MONITORING YEAR 4

MOORES FORK STREAM MITIGATION PROJECT

DMS Project Number 94709

Wildlands Engineering, Inc. (Wildlands) has reviewed the Division of Mitigation Services (DMS) comments from the Draft Monitoring Year 4 report for the Moores Fork Stream Mitigation Project. The following Wildlands responses to DMS's report comments are noted in italics lettering.

Figure 3.0 Integrated Current Condition Plan View (Key)
 Moores Fork Stream Mitigation Project
 DMS Project No. 94709
 Monitoring Year 4 - 2019

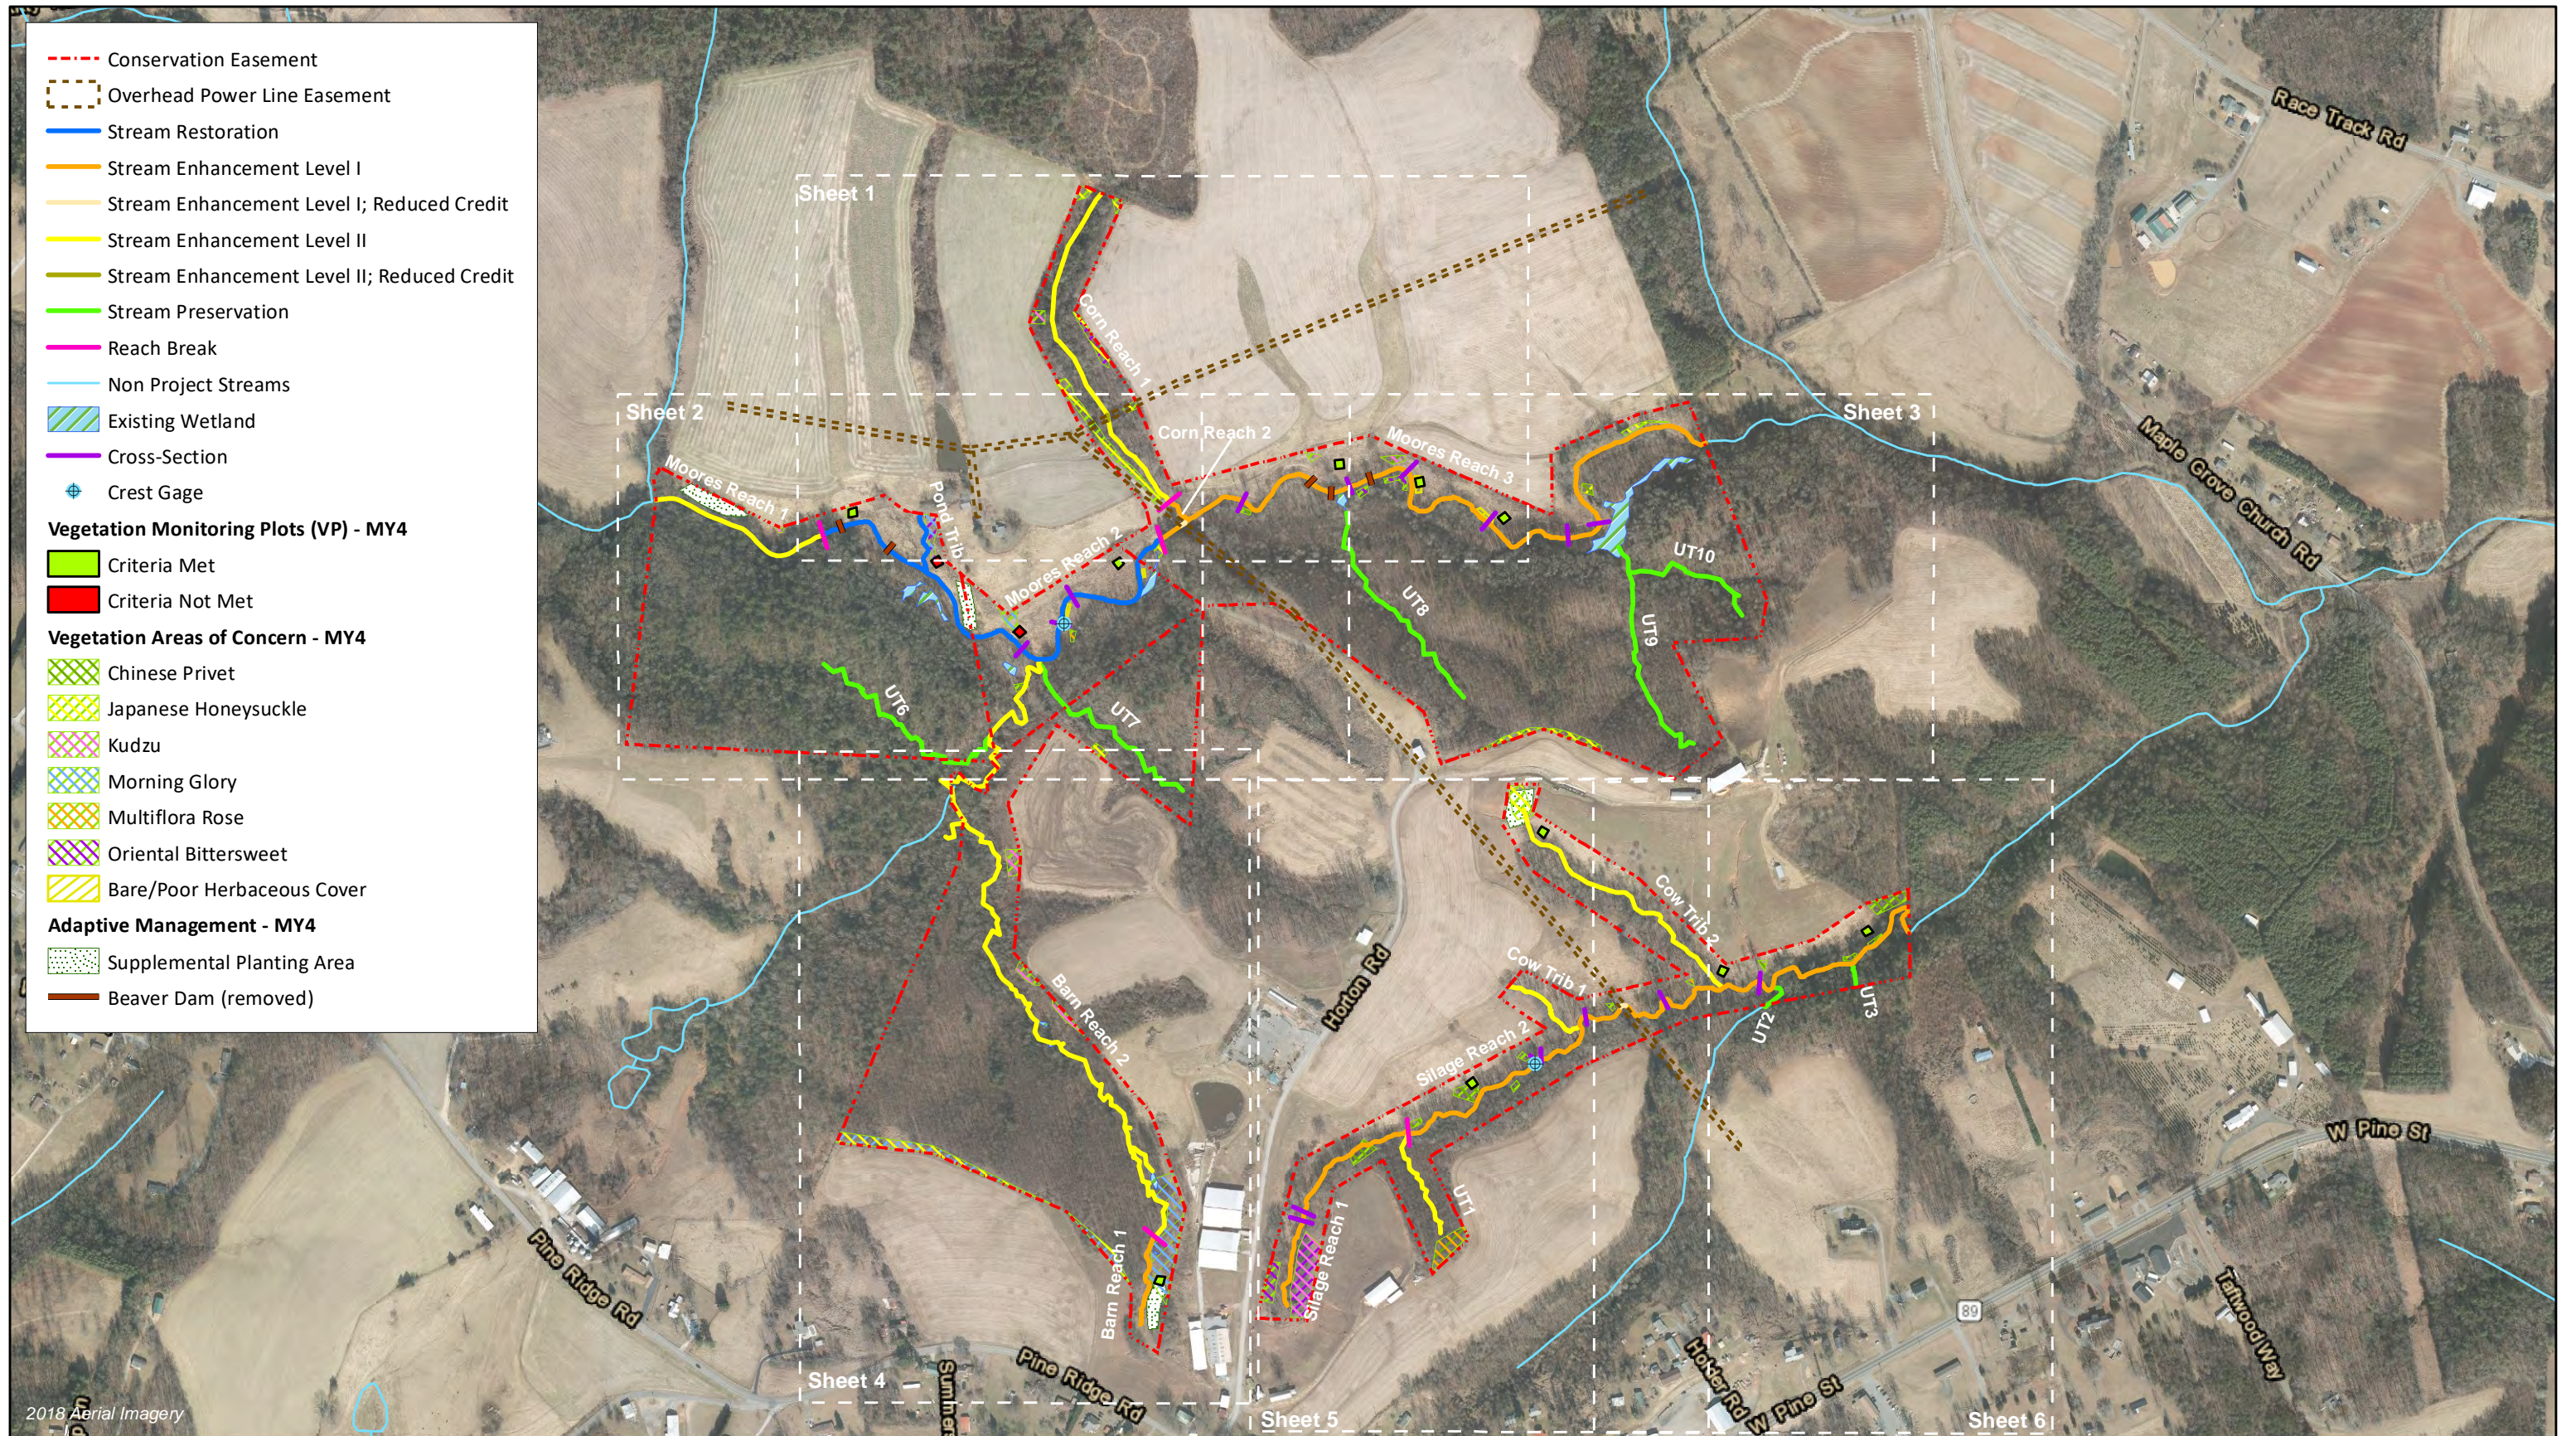
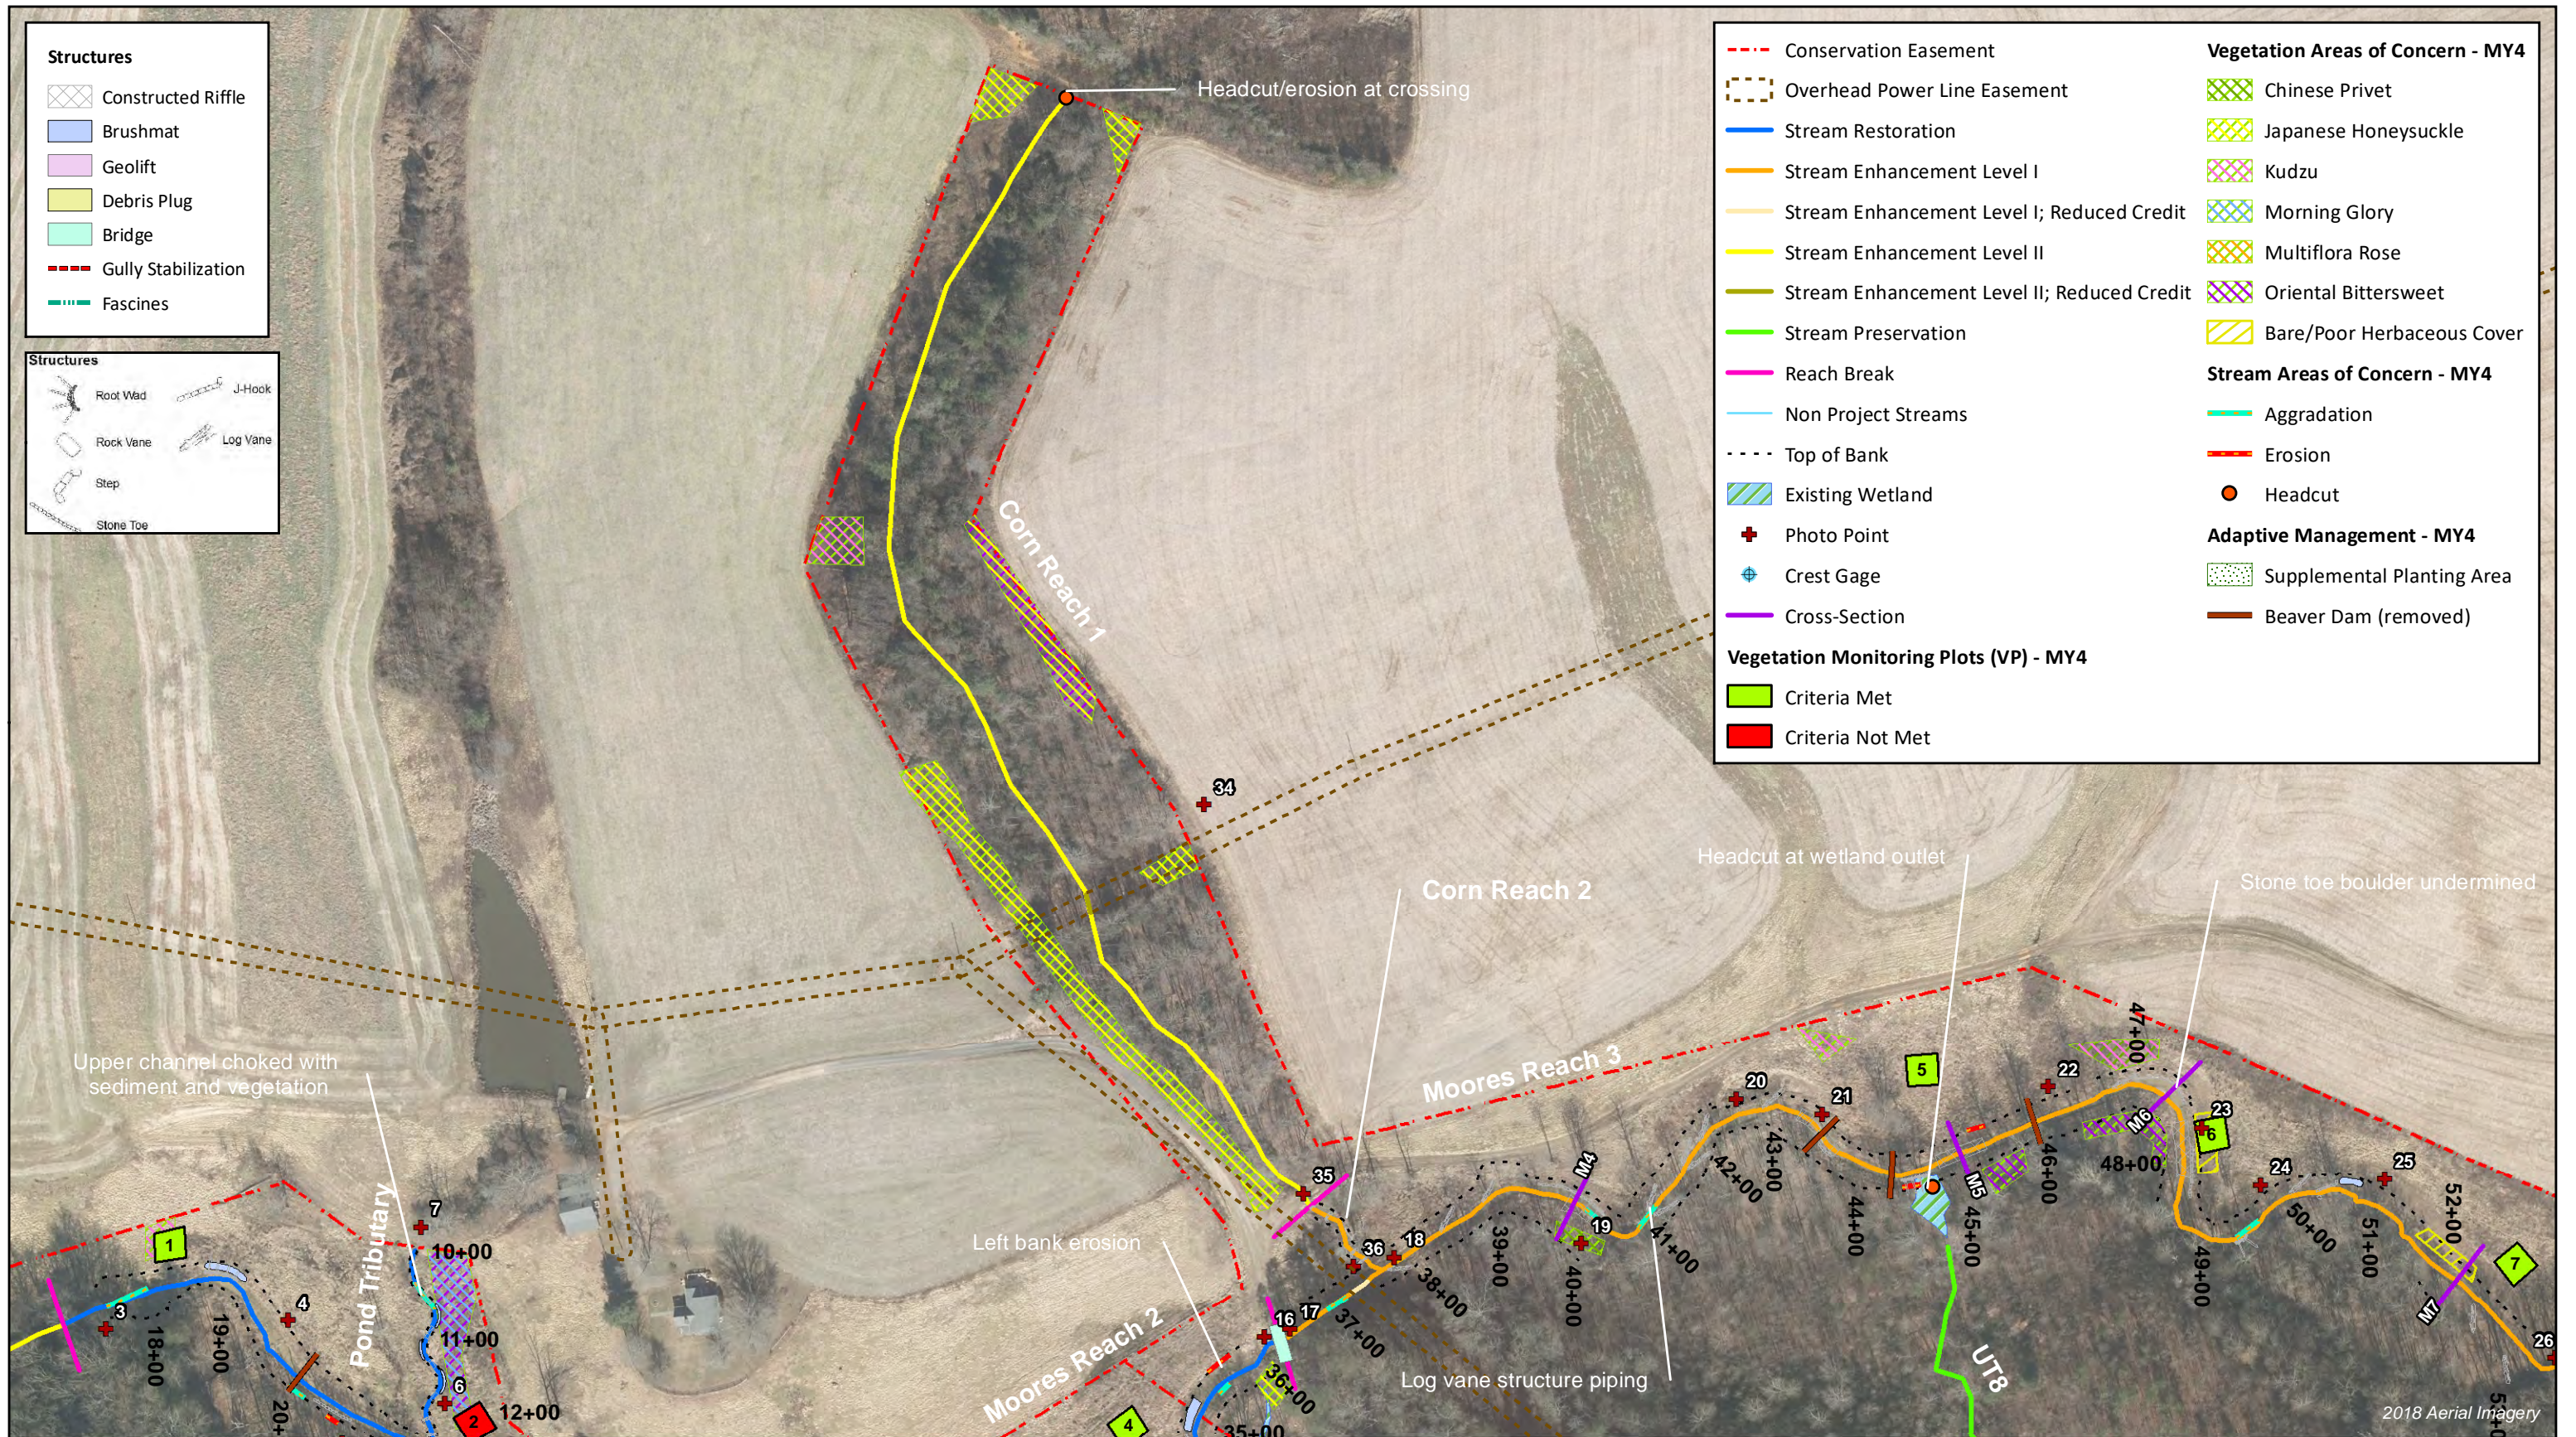
DMS comment; 1.2.2 Vegetation Areas of Concern: The supplemental planting that was completed in March 2019 consisted of 400 bare roots spread across four areas of the site determined to have low stem density based on the MY3 plant warranty inspection report. A pdf of the areas has been included. Please add these areas to the CCPV.

continue to monitor the site for beaver activity through closeout. A map is included with approximate locations of the dams. Please add this to the CCPV.

DMS comment; CCPV: Thanks for providing updated invasive species polygons. Please continue to update as treatment occurs and populations are reduced. This map is a useful tool for the contractor treating the site.

Wildlands response; Text was added to Section 1.2.2 to indicate that 400 bare roots were planted in March 2019. The four areas where supplemental planting took place were added to the CCPV.

Wildlands response; Text was added to Section 1.2.4 to detail the management of beaver activity for the Site in 2019. The approximate locations of the dams were added to the CCPV.

Wildlands response; Wildlands will continue to update the CCPV figures as treatment of invasive species occurs and populations are reduced.
